SUNDRY NOTICES AND REPORTS ON WELLS

B.V. Lynch #9

30-025 02490

Permanent Abandonment of Federal Wells
Conditions of Approval (LPC Habitat)

Well Name: E.V. Lynch A#9

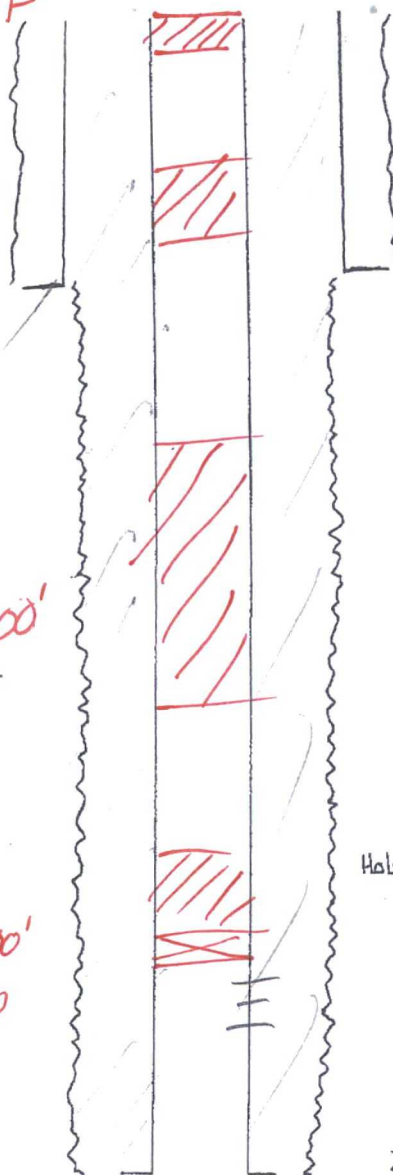
Circ cmt from 60-Surf

Spot 25 Sx
from 400-300'

Surf csg
Pulled

Formation Tops
RSR 1615
TOS 1750
BOS 3115

Spot 150 Sx
from 3165-1700'
Tag

CIBP@ 3400'
w/25 Sx on top
